Amendment C134 to the Moreland Planning Scheme

Expert Urban Design Evidence in relation
to the Sydney Road and Upfield Corridor

Mark Sheppard
February 2015

Instructed by
Maddocks Lawyers
On behalf of
Moreland City Council

Cross section through Sydney Road showing normal human field of view and 11m high street wall

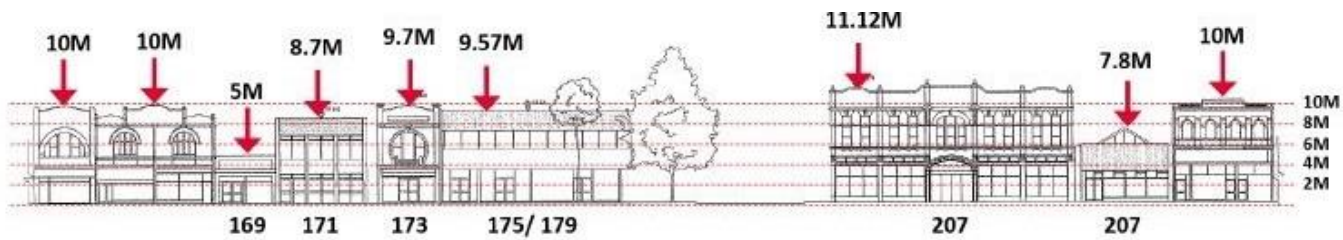
[50] A secondary benefit of maintaining this building scale at the street edge is that it is about the height that can be seen clearly by someone standing on the opposite side of the street without tilting their head. Therefore, it enables them to appreciate a complete component of the building form, rather than just the lower part of an element that disappears above their normal field of view.

Proposed maximum heights at different setbacks on Sydney Road

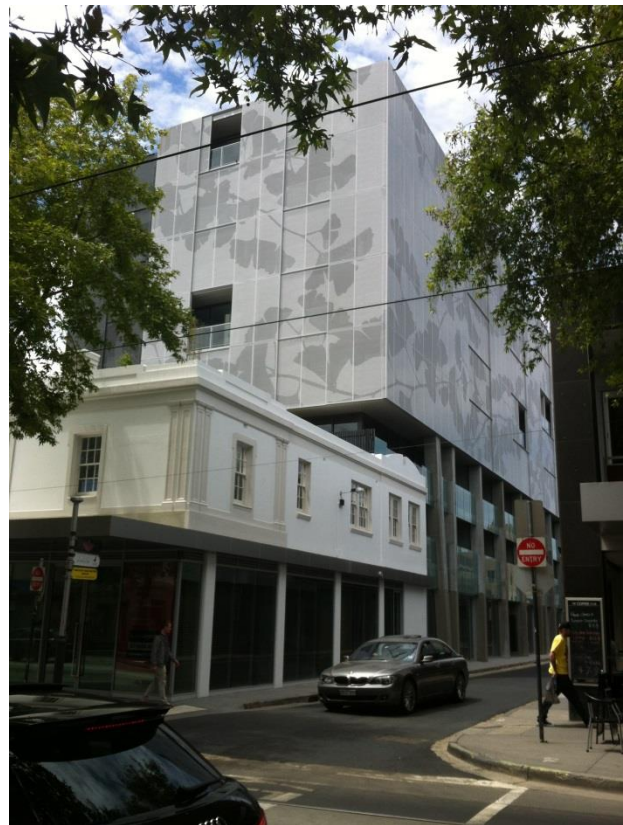
- have a distinct and visually recessive architectural expression.
- [84] In practice, this results in a maximum overall height of 19m at a 5m setback, 22.5m at a 10m setback or 25m at a 14m setback, as shown below (or any of an infinite number of other height and setback relationships that maintain the same viewcone).

- [86] Ultimately, the height of buildings in Sydney Road will be limited by this proposed control. For example, on a 32m deep lot that abuts a residential property at the rear (such as between Stewart and Blyth Streets), it will limit height to 19m at a 5m setback, and there would probably be insufficient depth to go higher with a bigger setback. But on a 48m deep lot such as those north of Warr Park, an overall height of around 30m might be possible.

- [88] A question that needs to be considered is whether the upper form envelope should be lowered if a street wall lower than 11m high is proposed, because it ought to occupy no more than 1/4 of the overall vertical viewcone of the building. While this is unlikely with an entirely new building, because the applicant is likely to maximise the street wall height in order to maximise the overall height, it might occur if the front of the existing building is to be retained for heritage reasons, and is notably below 11m in height.

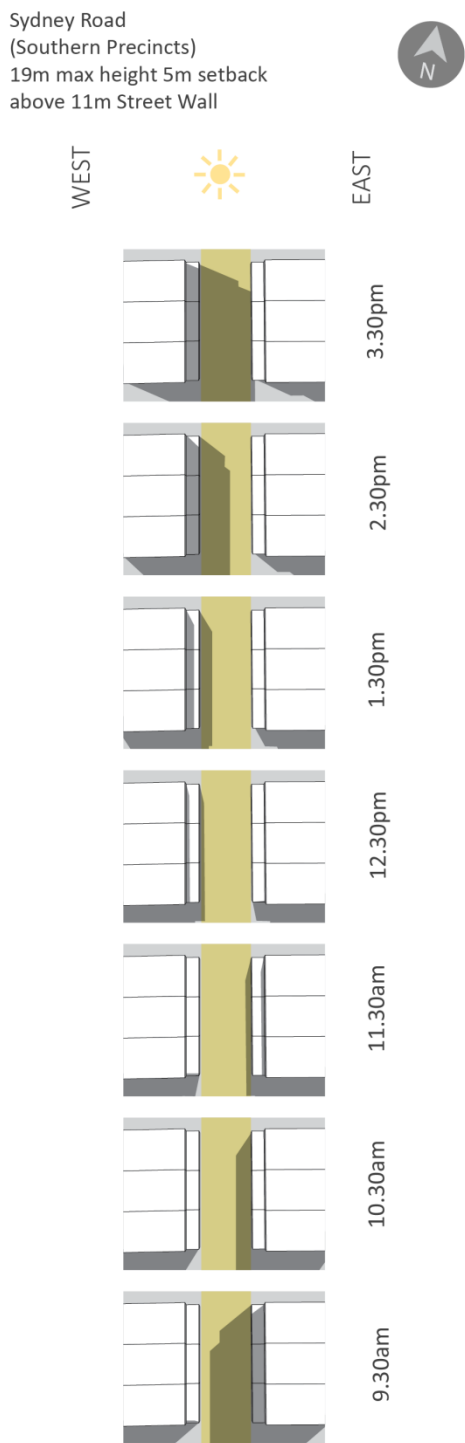
- [93] The DDO faithfully translates the recommendations of the SFP in relation to the angled plane controlling building form above the street wall. However, it is not absolutely clear where the viewlines are to be measured from on the opposite side of the street. (On what part of the footpath?)

Further, given my opinion that the angle of the built form envelope should be fixed, rather than varying with the height of the street wall, it may be simpler to replace the sightline diagram with a more straightforward building envelope, with a dimensioned angled line leading from the top of the 19m high building form at a 5m setback.

- [94] The DDO also proposes that the 5m and 75% common setback requirements be mandatory. I do not support a mandatory 5m setback, for the reasons outlined above. Nor do I support the 75% control being mandatory, because it is ultimately only a guide to good design, and skilled architects may find an alternative solution that is successful despite varying from it.
- [95] The DDO does not contain a requirement in relation to development adjacent to civic buildings and heritage places. I consider that a requirement such as that recommended by the SFP should be added to ensure that development is appropriately respectful of these key civic and heritage buildings.
